From: Mcpherson, Benjamin J (DEC)
Sent: Friday, October 21, 2022 10:44 AM
To: Brian Robinson
Subject: RE: 350 Franklin RAWP Figure 6c

From: Brian Robinson <brobinson@rouxinc.com>
Sent: Thursday, October 20, 2022 3:11 PM
To: Mcpherson, Benjamin J (DEC) <benjamin.mcpherson@dec.ny.gov>
Subject: 350 Franklin RAWP Figure 6c

UNAUTHORIZED ALTERATION OR ADDITION TO THIS DOCUMENT IS A VIOLATION OF STATE LAW.				PROJ. ENGINEER: NC				DRAWN BY: AB				<div>PROJECT NAME: 350 FRANKLIN STREET OLEAN, NEW YORK</div> <div>PROJECT FOR: MJ PAINTING CONTRACTOR CORP.</div>												<div>TITLE: SUBSURFACE SOIL REUSE PLAN AREA 2</div>				<div>DRAWING NO. 6C</div> <div>DRAWING 6 OF 11</div>															
				THESE DOCUMENTS (OR COPIES OF ANY THEREOF) PREPARED BY OR BEARING THE SEAL OF THE ENGINEER, SHALL NOT BE REUSED FOR ANY EXTENSIONS OF THE PROJECT OR ANY OTHER PROJECT WITHOUT THE WRITTEN CONSENT OF THE ENGINEER.				DESIGNED BY: AB				CHECKED BY: BR

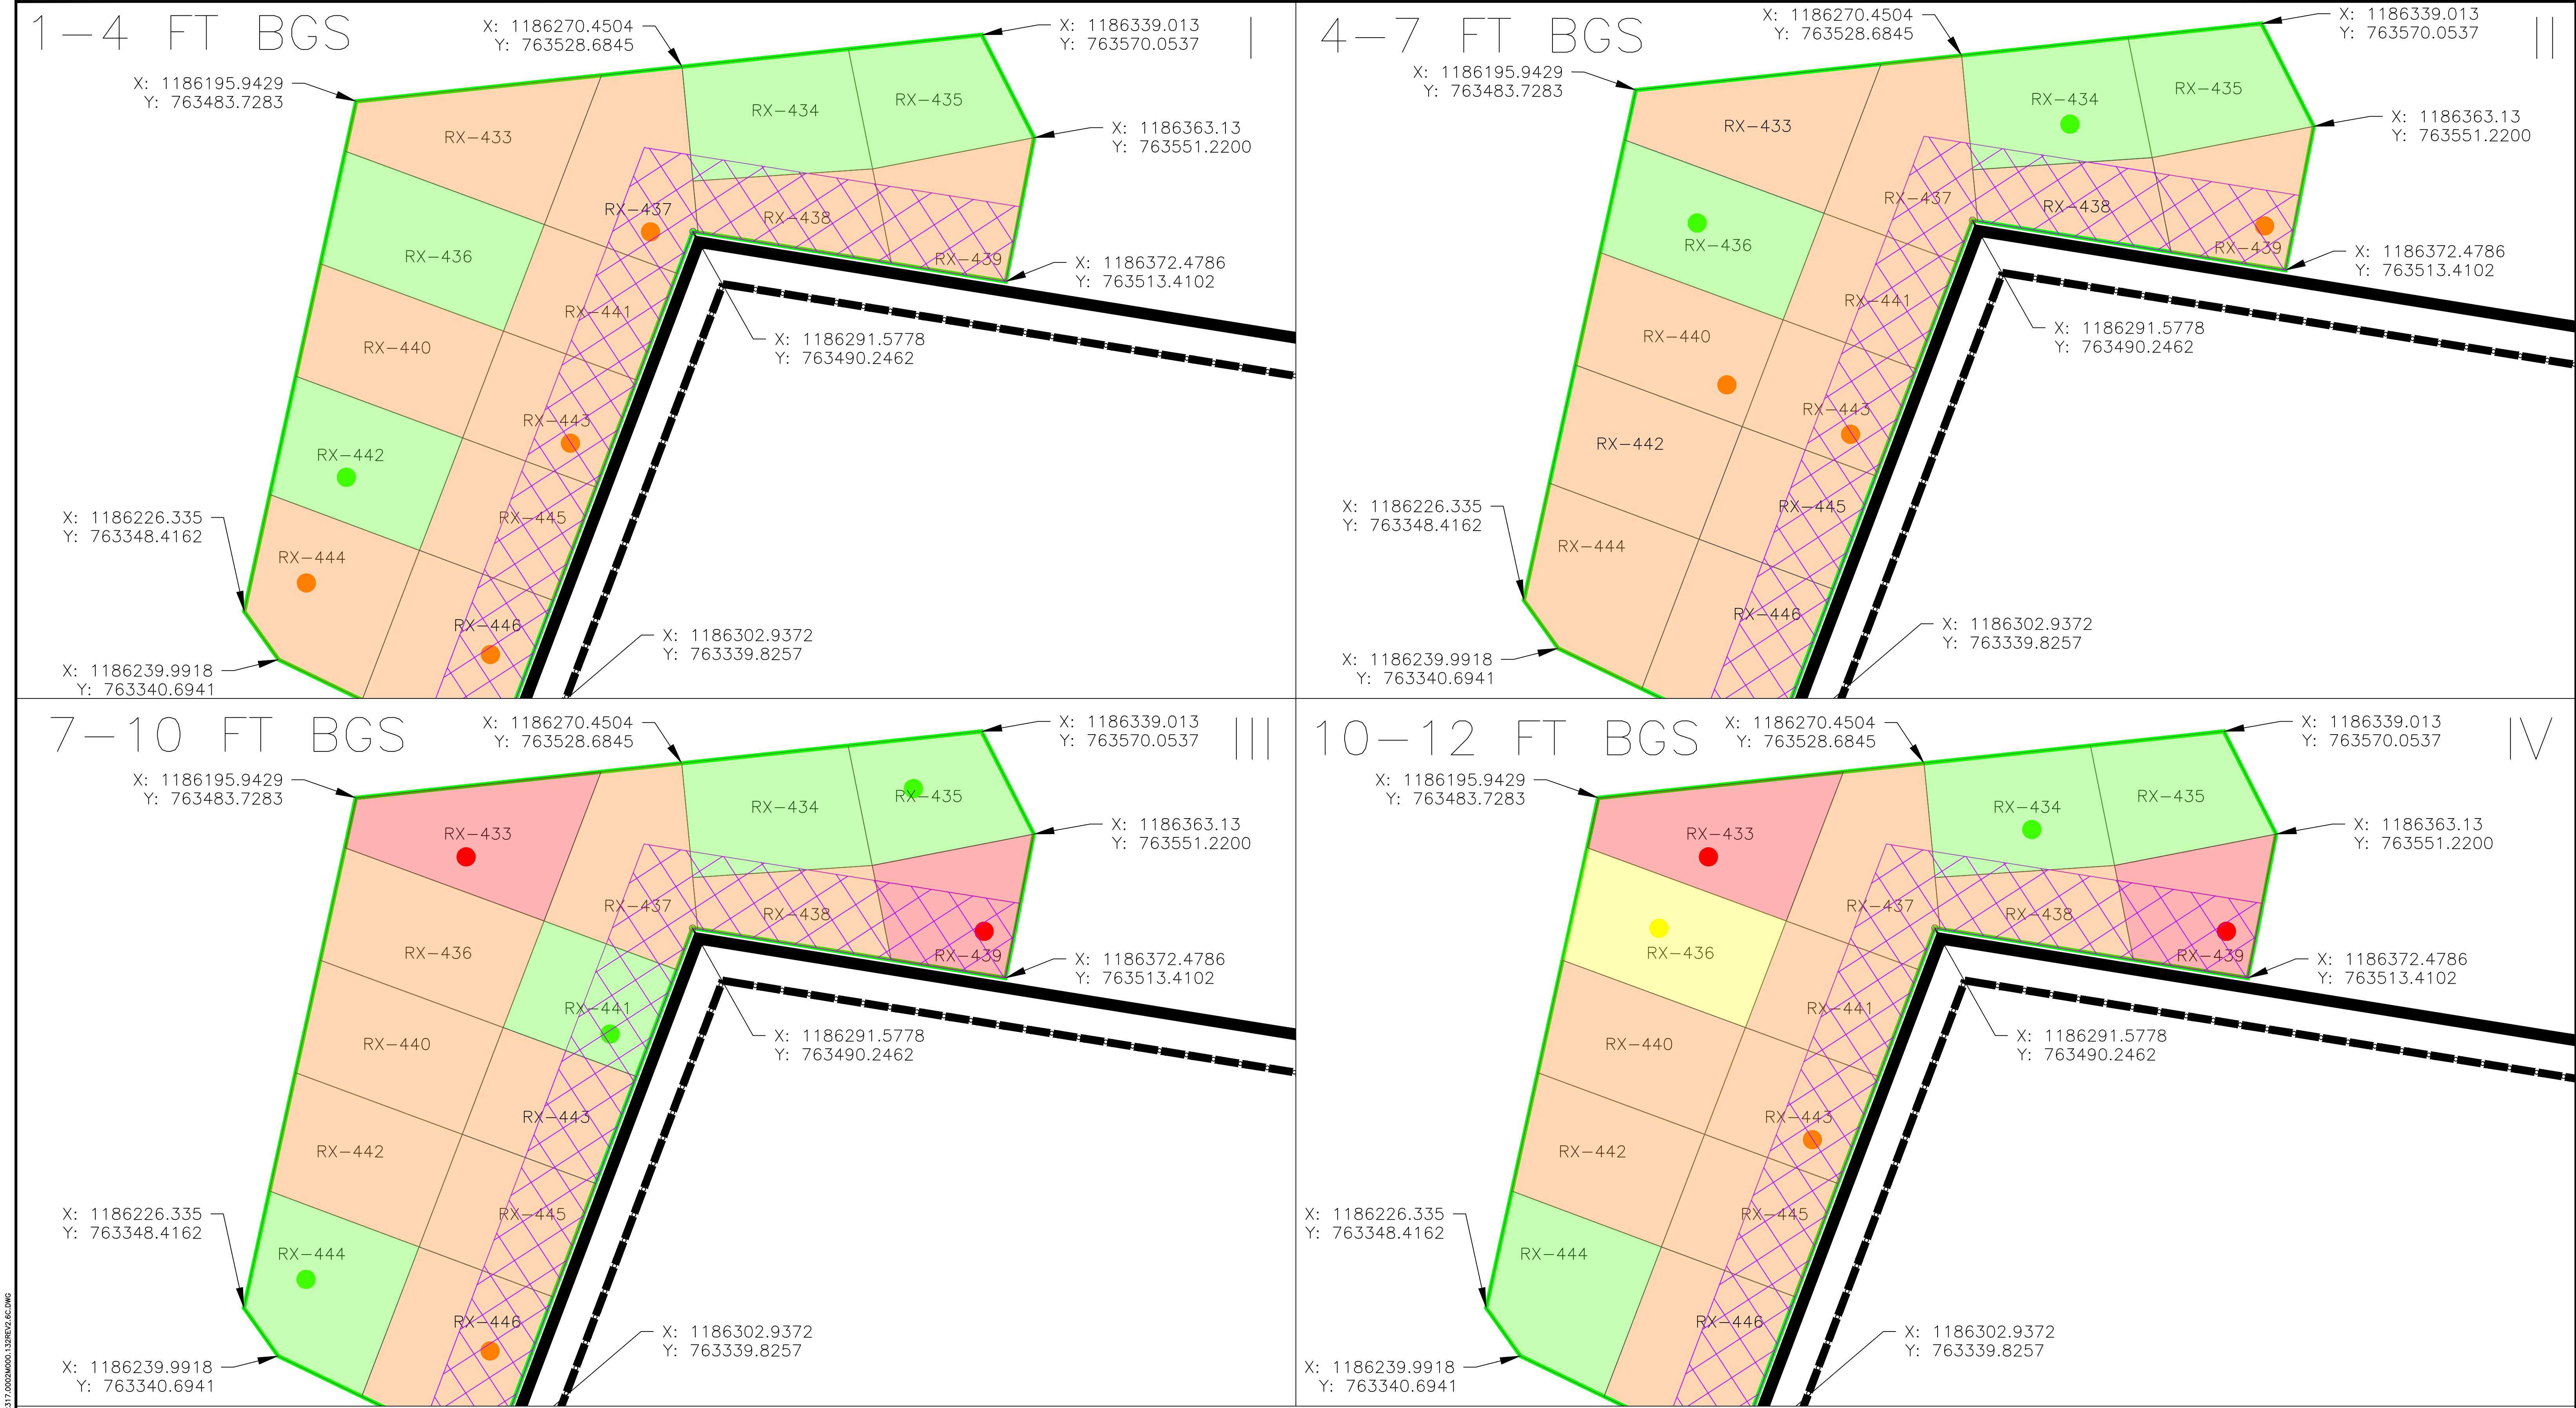
In planning for the potential to begin the phase 2 gravity wall I noticed that the Phase 2 remedial boundary depicted in Figure 6C of our RAWP are not consistent with the area shown in other figures in that same package (see Final RAWP Package Figs 4A, 7, 8, 9). Please see the updated New Figure 6C for the proper remedial boundaries with corrected X,Y benchmarks.

Our plan is to remediate the New Figure 6C area, consistent with the rest of the submitted drawing package, and reuse or dispose of soils as indicated. Sorry for the confusion in the original submittal. Please let me know if you have any questions or comments.

Thank you for the updated figure. I do not have any question on the corrected Phase II outline.
